THE MARYLAND-NATIONAL CAPITAL PARK AND PLANNING COMMISSION

## MEMORANDUM

**REVIEW TYPE:** Site Plan Review  
**CASE #:** 8-04002  
**PROJECT NAME:** Oakridge Corporate Centre – Flex Park  
**APPLYING FOR:** Approval of 252,000 square feet of research and development space in three two-story buildings

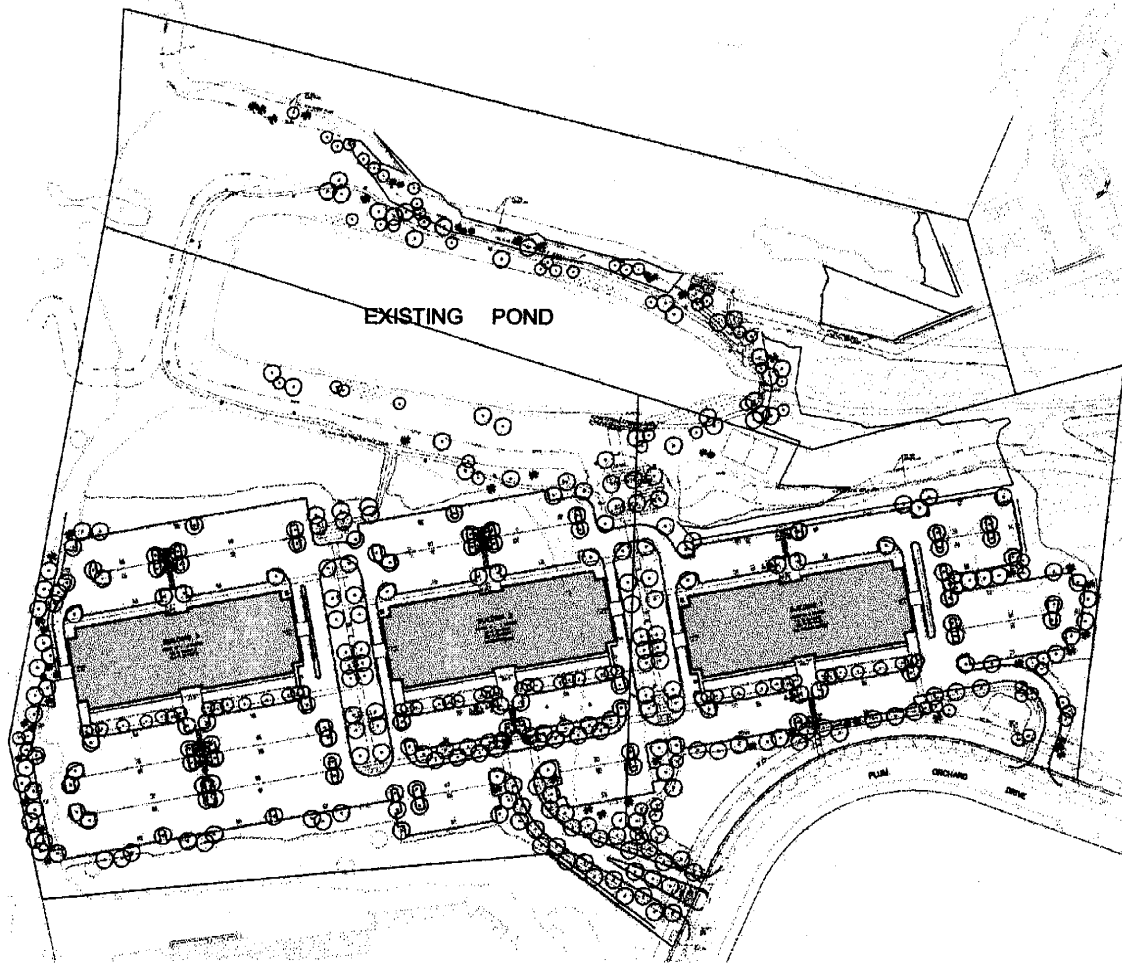
- b. Revise the preliminary forest conservation plan as follows:
  - i. Revise forest conservation plan worksheet to include SWM easement area.
  - ii. Show how required reforestation amount will be met.

- i. Provide sediment and erosion control plan with final forest conservation plan.
  - ii. Show proposed grading and limits of disturbance for shelter on the west side of the stormwater management pond. No forest clearing shall occur to locate the shelter.

- iii. Retain the services of a licensed arborist with experience in protecting trees near significant fill slopes to provide recommendations for protecting tree no. 13 (31-inch white oak). Measures to be incorporated into the final forest conservation plan and to include, but not limited to, a retaining wall.

- iv. Relocate part of the 12-inch sewer line in the back of Building 2 to avoid clearing of forest in forest preservation area no. 2.
  - v. For each tree-save area that is to be credited towards the reforestation requirement, provide supplemental planting at the minimum rate of 7 trees and 20 shrubs per 2500 square feet unless it is determined at the pre-planting meeting that existing trees and shrubs meet this criterion.

- d. Provide a groundwater recharge area for wetland adjacent to parking lot on north side of property. Design of recharge area to be reviewed and approved by DPS.

- e. Paved path within environmental buffer area shall be located as shown on the approved site plan and be no more than 5 feet wide.
- f. Volleyball court shall be made of pervious material.

Staff disagrees with the applicant and believes the SWM easement should be included as part of the net tract area for purposes of the forest conservation plan. Staff's recommended conditions 2bi and 2bii would require that the preliminary forest conservation be revised to include the SWM easement. Including the SWM easement as part of the net tract would result in a reforestation requirement of approximately 1.4 acres, instead of 0.44 acre. In other cases, a stormwater management pond and its easement are not excluded from the net tract area in a forest conservation plan if they lie on the same property as the proposed project. In addition, in this case, the pond is not only being used for the project's stormwater management controls, but it is also being used as part of the project's amenity and green space. A hard-surface path is proposed to encircle the pond. A volleyball court is proposed to lie within the existing SWM easement.

Of the 14 large and specimen trees, four will be retained. These trees are along the edges of the property and near the environmental buffer. Staff recommends that an additional large tree (a 31-inch white oak) be retained. The oak is near the parking lot in the back of Building 1. Staff recommends that a licensed arborist be retained to identify the appropriate tree protection measures for the oak. Staff believes that one of the protection measures will be a retaining wall around part of the critical root zone that will be located adjacent to the parking lot and on the fill slope.

The part of a parking lot that is proposed to encroach into the environmental buffer would fill in about 0.04 acre (1900 square feet) of an existing, 0.39-acre (16,772 square feet) wetland area that appears to receive groundwater from the adjoining forested upland slope. Since the upland slope will be developed and primarily covered in pavement and a building, the natural recharge function of the slope will be eliminated and the wetland may dry up. The proposed buffer encroachment (wetland and its buffer) by the parking lot is 11,739 square feet (0.27 acre). Staff believes the encroachment would be acceptable if, in addition to reforesting an area equal to the encroachment (as discussed in the preceding paragraph), some of the stormwater runoff from the development is directed into a created groundwater recharge area adjacent to the remaining wetland to help maintain groundwater flows to the wetland. The applicant is proposing to take stormwater runoff from the rooftop of building no. 1, which would be relatively clean, and directing the runoff into a groundwater recharge structure just uphill of the remaining wetland. Staff recommends that the proposed structure be reviewed and approved by MCDPS.
